SWIM PROJECT PROFILE		File No. : 194
Regist. No. : Agency No. : BSWM-113	Name: LABOON SWIP	
Region: 8	Province: SOUTHERN LEYTE	Municipality: MAASIN
Present Status: 1. Pre-F/S( )    ② F/S(1983)    ③ D/D(1983)		
Purpose: Major : Irrigation Incidental : IF, FC, WM		
Project Feature:

SWIM PROJECT PROFILE		File No. : 195
Regist. No. : Agency No. : BSWM-114	Name: POLANQUI SWIP	
Region: 8	Province: EASTERN SAMAR	Municipality: TAFT
Present Status: 1. Pre-F/S( ) ② F/S(1983) ③ D/D(1983)		
Purposo: Major : Irrigation Incidental : IF, FC, WM		
Project Feature:

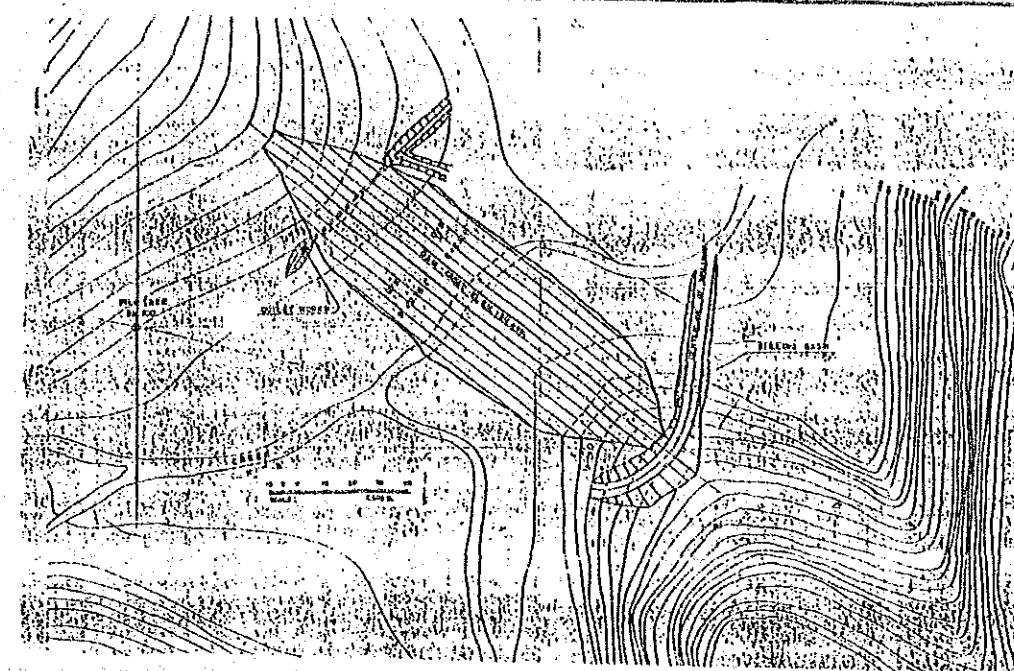
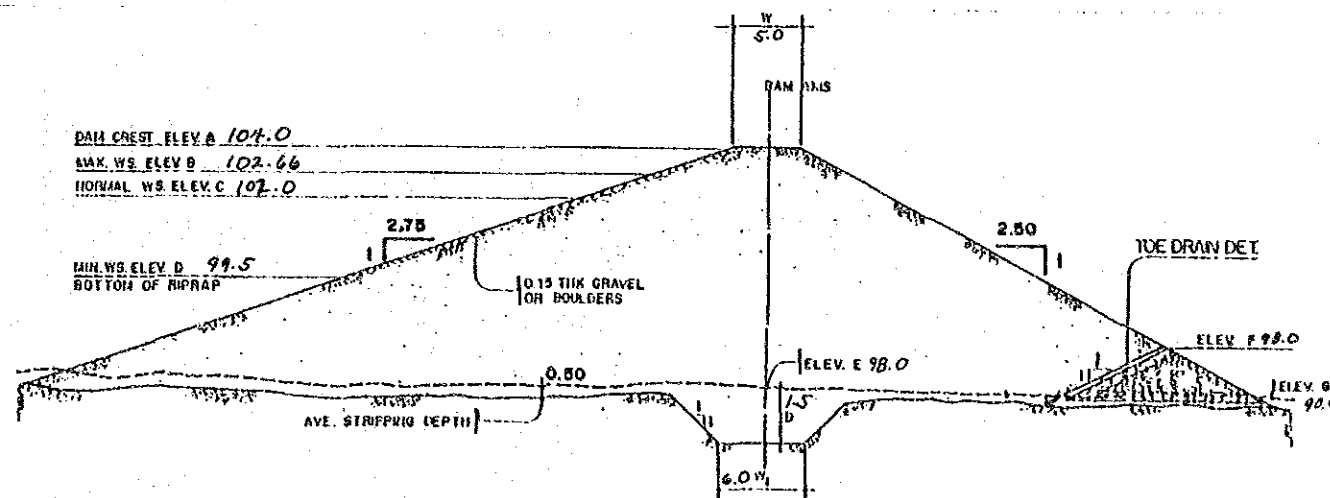
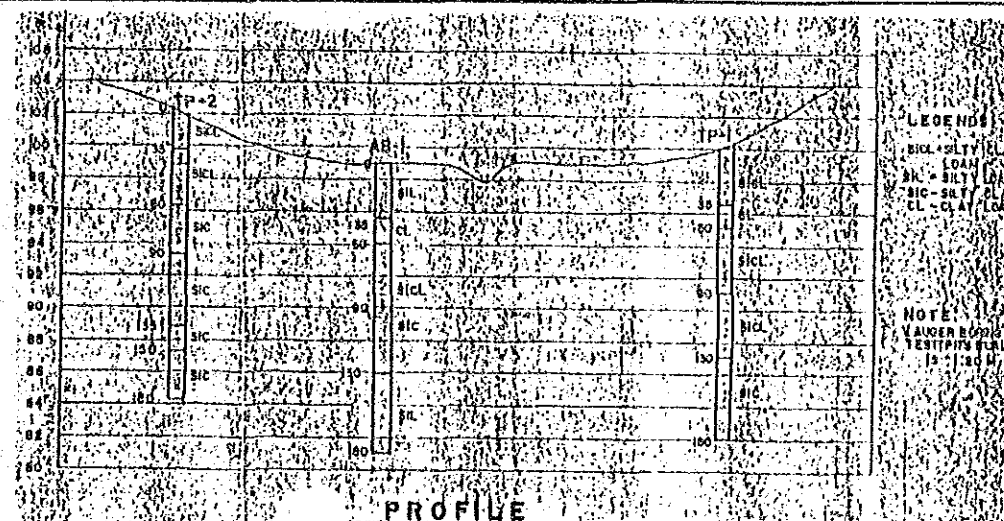
6. Inland Fishery	Annual Production :	6 ton/year
Technical Assessment:		
1. Survey and Investigation: Depth of test pit or auger boring is not enough. Bearing capacity and permeability are not measured. Available volume for dam embankment shall be studied before construction.

2. Planning Environmental conservation plan is not formulated.		
3. Design Depth of core trench shall be modified during construction. Stability of upstream slope of the dam shall be checked. Center line of the spillway shall be shifted to right side. Weir shall be provided in the spillway.

Note: Clay with more than 1.8 m depth is piled up on the sand stone, mud stone and shale.

SWIM PROJECT PROFILE		File No. : 196
Regist. No. : Agency No. : BSWM-115	Name: TABAWAN SWIP	
Region: 8	Province: WESTERN SAMAR	Municipality: TABAWAN, CALBAYOG CITY
Present Status: 1. Pre-F/S( ) (2) F/S(1983) (3) D/D(1983)		
Purpose: Major : Irrigation Incidental : IF, FC, WM		
Project Feature:

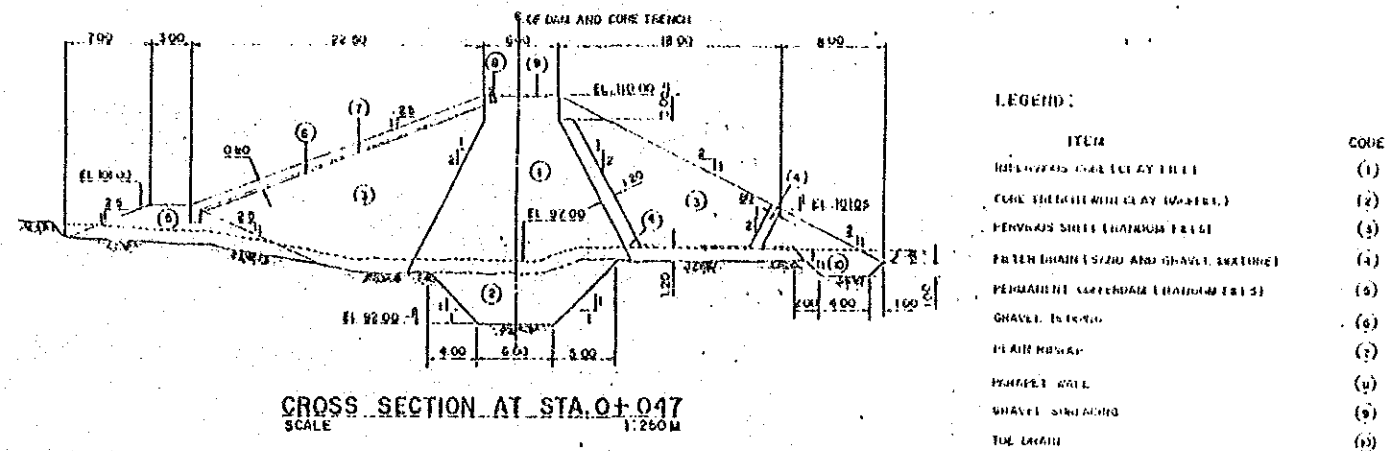
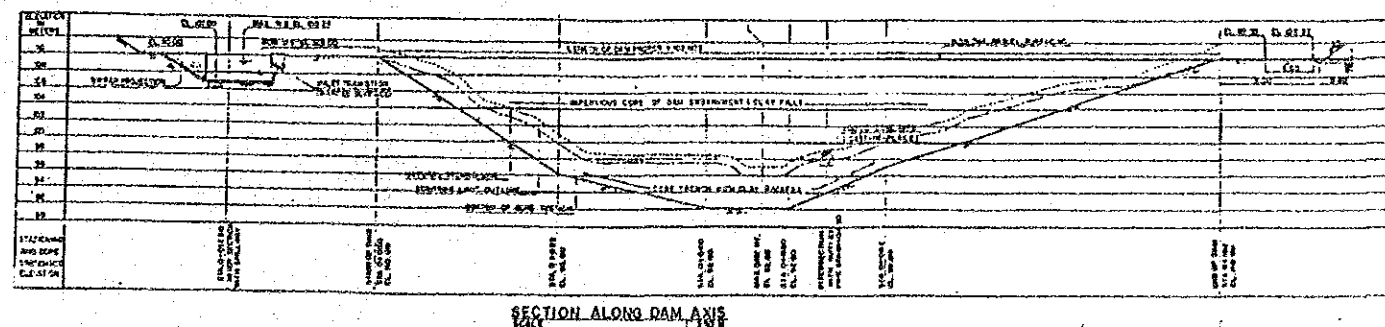
6. Inland Fishery	: Annual Production	: 3 ton/year
Technical Assessment:		
1. Survey and Investigation: Depth of test pit or auger boring is not enough. Bearing capacity and permeability are not measured. Available volume for dam embankment shall be studied before construction.

2. Planning Formulations of both agricultural development plan and irrigation development plan are not mentioned. Environmental conservation plan is not formulated.

3. Design Depth of core trench shall be modified during construction. Stability of upstream slope of the dam shall be checked. Inlet of the outlet works is recommended to be located in outside of embankment.

SWIM PROJECT PROFILE		File No. : 197
Regist. No. : Agency No. : BSWM-117	Name: WOODLAND SWIP	
Region: 9	Province: ZAMBOANGA DEL SUR	Municipality: BEGONG, DUMALINAO
Present Status: 1. Pre-F/S( ) ② F/S(1983) ③ D/D(1983)		
Purpose: Major : Irrigation Incidental : IF, FC, WM		
Project Feature:

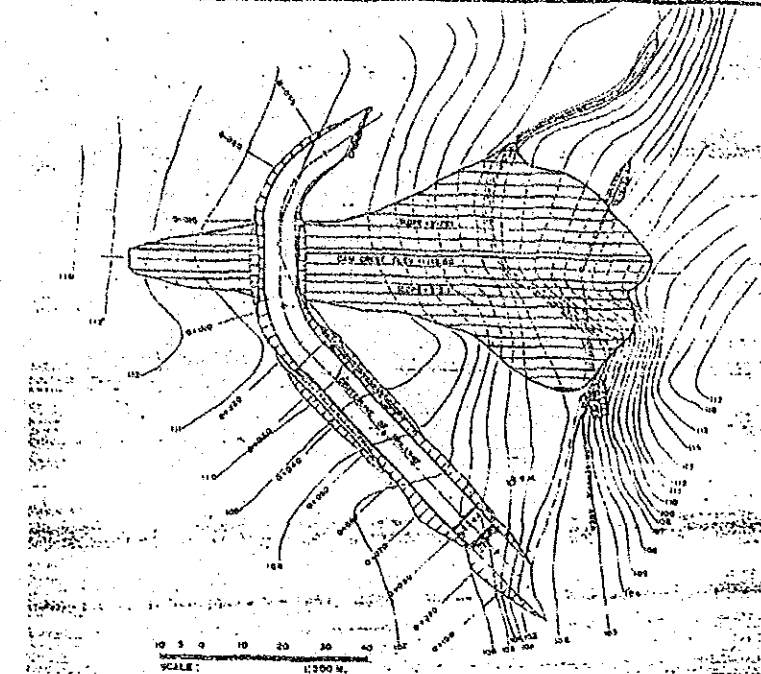
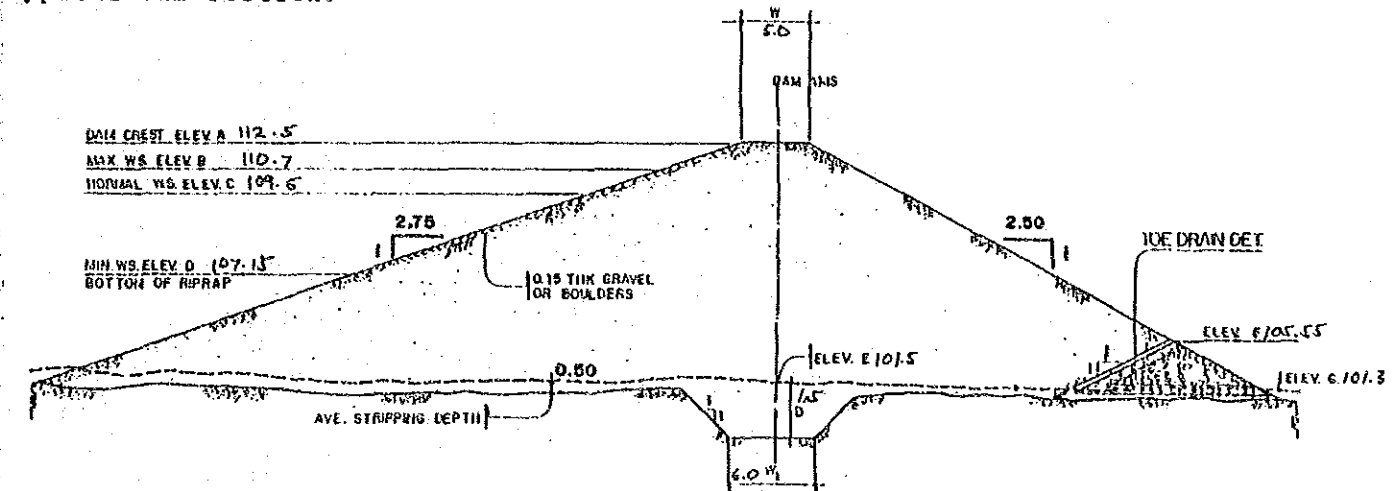
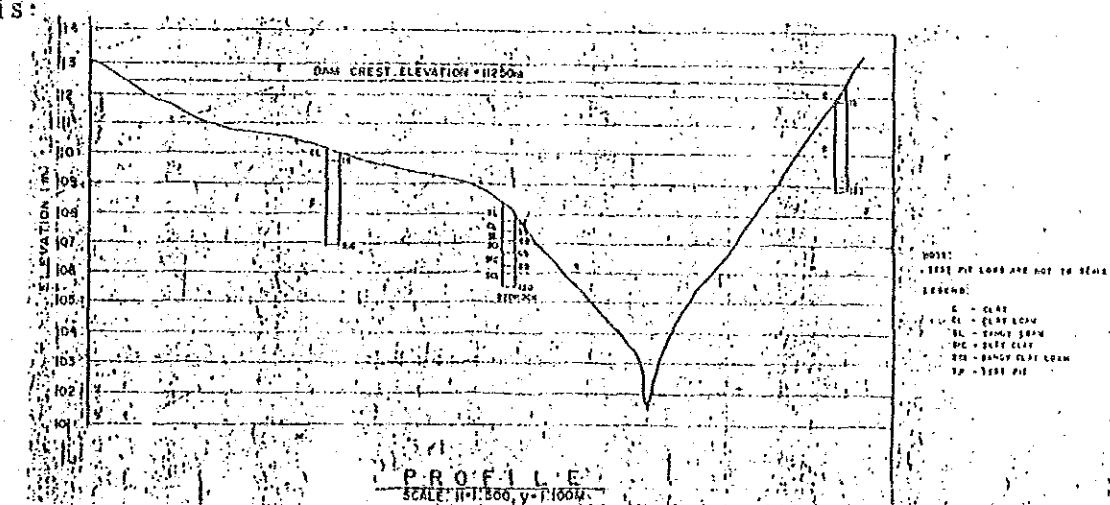
6. Inland Fishery	: Annual Production	: 6 ton/year
Technical Assessment:		
1. Survey and Investigation: Depth of test pit or auger boring is not enough. Bearing capacity and permeability are not measured. Available volume for dam embankment shall be studied before construction.

2. Planning Environmental conservation plan is not formulated.		
3. Design Depth of core trench shall be modified during construction. Stability of upstream slope of the dam shall be checked. Compaction near the spillway shall be carefully carried out. Weir shall be provided in the spillway. Center line of conduit is recommended to be straight.

SWIM PROJECT PROFILE		File No. : 198
Regist. No. : Agency No. : BSWM-118	Name : SUMADAT SWIP	
Region : 9	Province : ZAMBOANGA DEL SUR	Municipality : DUMALINAO
Present Status: 1. Pre-F/S( )    ② F/S(1983)    ③ D/D(1983)		
Purpose: Major : Irrigation Incidental : IF, FC, WM		
Project Feature:

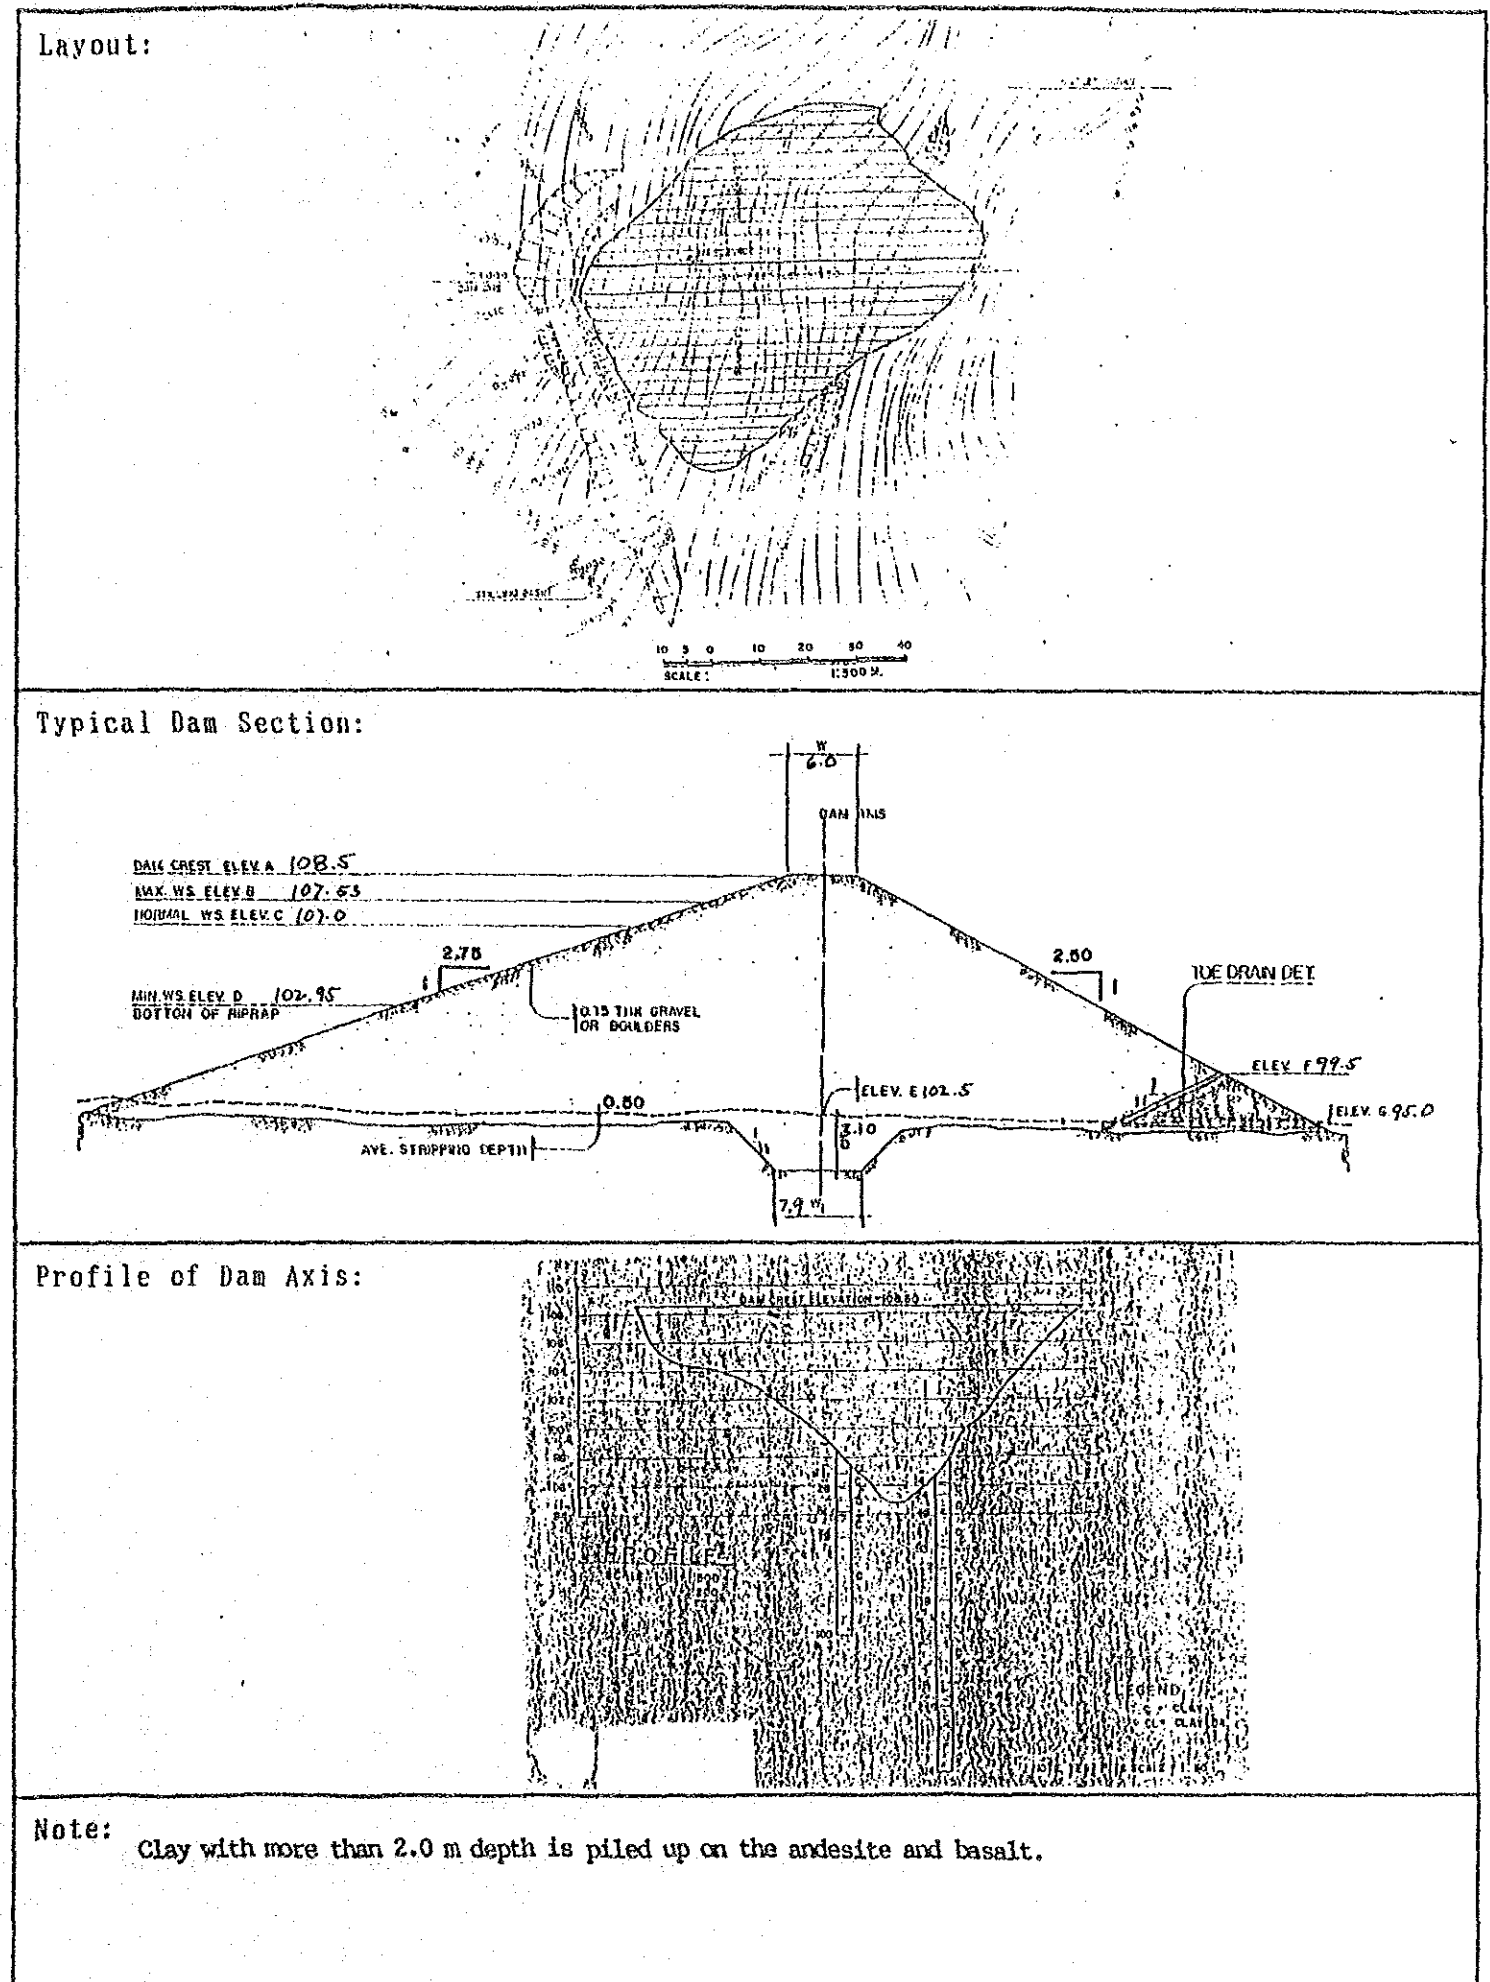
6. Inland Fishery	: Annual Production	: 2 ton/year
Technical Assessment:		
1. Survey and Investigation: Depth of test pit or auger boring is not enough. Bearing capacity and permeability are not measured. Available volume for dam embankment shall be studied before construction.

2. Planning Environmental conservation plan is not formulated.		
3. Design Depth of core trench shall be modified during construction. Stability of upstream slope of the dam shall be checked. Weir shall be provided in the spillway.
